## CHART STANDARDIZATION & PAPER CHART WORKING GROUP (CSPCWG)

### CSPCWG Letter: 11/2009

#### **Subject: Actions from CSPCWG5 (Round 2)**

**Selected Actions from CSPCWG5  
CONSOLIDATED RESPONSES TO CSPCWG LETTER 7/2009**

N°11 – Example from FR 7213

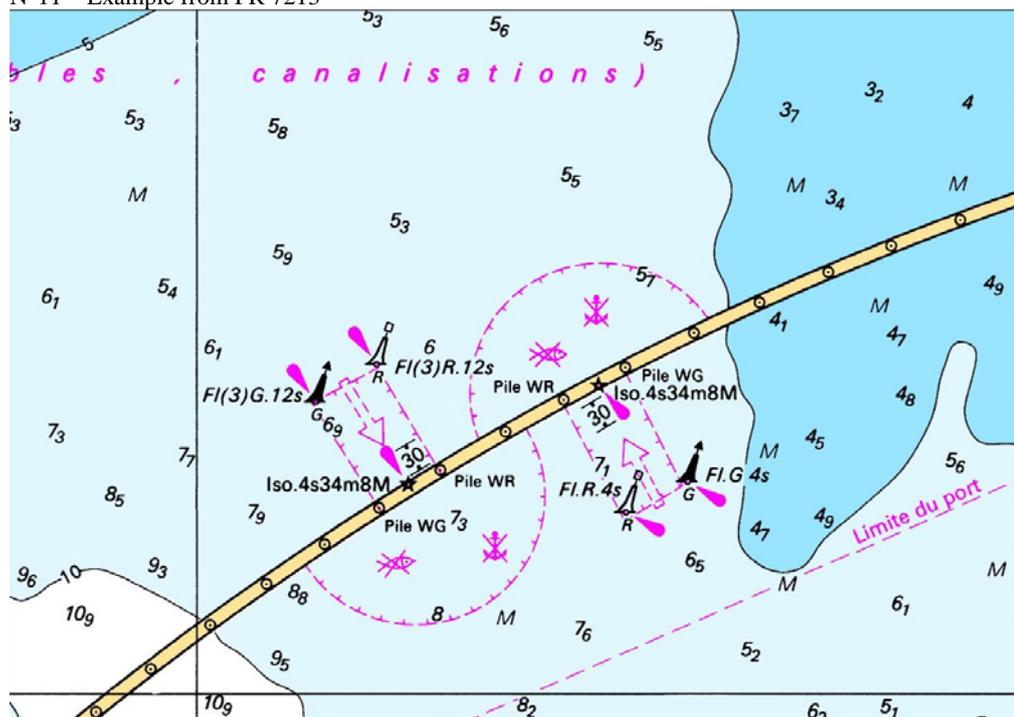
**I do not think this example is as useful as others. It is not clear what the unlabelled ‘fixed position’ circles along the bridge are. Also, the word ‘Pile’ is not appropriate in English for a bridge support.**

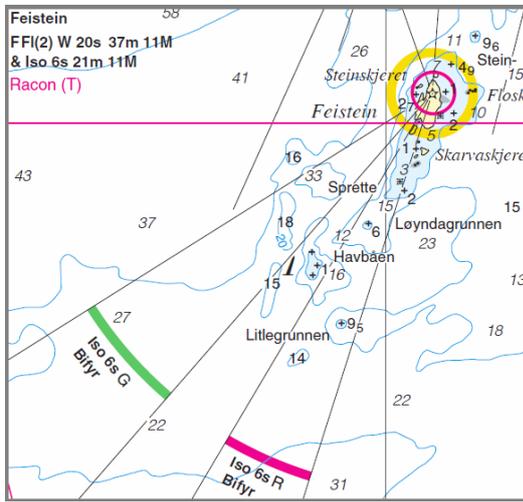
The chart segment below shows the Norwegian way of using the & to separate the two different characteristics for a light with subsidiary light (P-42). (The subsidiary light is installed lower in the same structure as the main light).

Since the FFI is a character belonging to one single light installation showing a fixed light varied at regular intervals by a flash of higher intensity, we vote for keeping the FFI because we think it gives a better expression of this actual kind of light.

This is helpful.

*This example is from the Swedish Chart 523. In this geographical area sunken timber has made it impossible to perform any hydrographical surveys near the shoreline.*

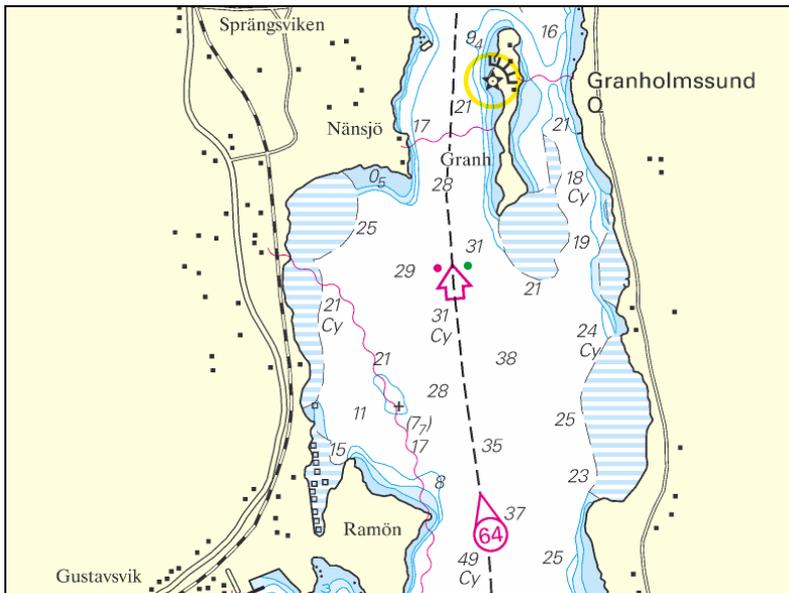
In certain cases where there are many small unsurveyed areas it is impossible to use the existing S-4 standard since the chart would become too cluttered with the legend “Unsurveyed” if portrayal were made according to the standard. That was one of the reasons why Denmark, Finland, Norway and Sweden forwarded the proposal with blue bands, a symbology used in Swedish charts as a national symbol more than 40 years, in order to have a method in S-4 to portray unsurveyed areas in inshore waters such as coastal archipelagos where a positive form of warning is required. In such areas one wants to make sure that surface navigation is not performed. See also the example below where a commercial fairway is close to such unsurveyed areas:

May we include this example in S-4?

Example B

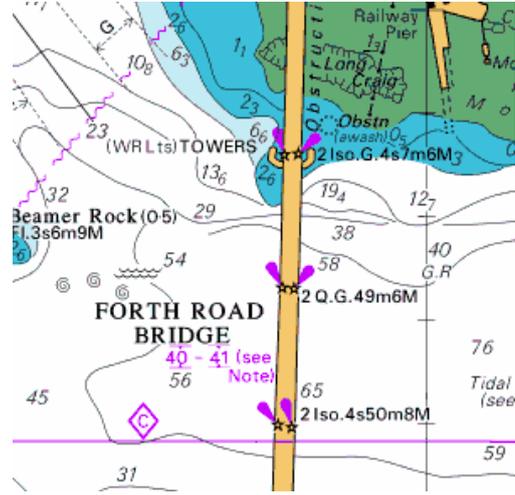
**Comment:** DID: please remove legend 'ABP HUMBER CHARTS (see Note)' from example B.

Example B (Source: United States Office of Coast Survey)

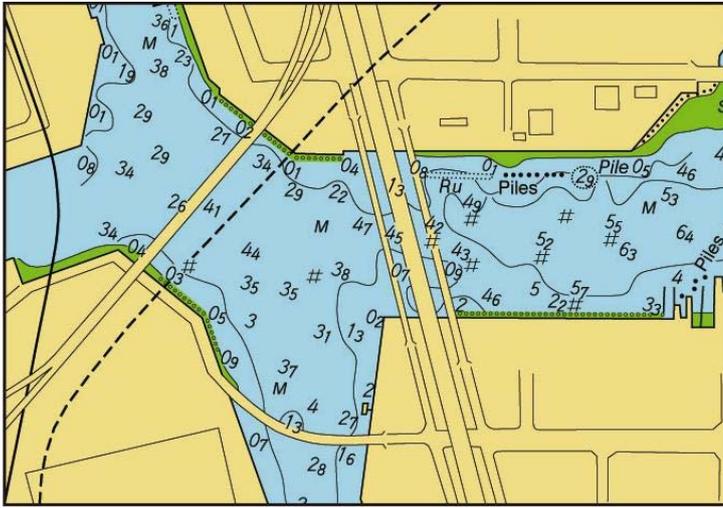
**Action 11 (Bridges).** I would like your thoughts on one further item, arising from the draft specification for bridges. The example provided by US (now B-381.6 Example B) shows the opening span of a bridge removed in order to show the depths underneath it. This is contrary to the advice in B-381.3 that opening bridges should be shown in the closed position. I am concerned that this practice could be misleading, by implying that the bridge is redundant and the span over the channel has been permanently removed. I would welcome your views.

**Comment:** UK believes this is confusing as first impression is that the span has been permanently removed (as in a redundant bridge) and there is no air draught (draft) limit between the central supports. It is contrary to B-381.3 which indicates that bridges should be shown in the closed position.
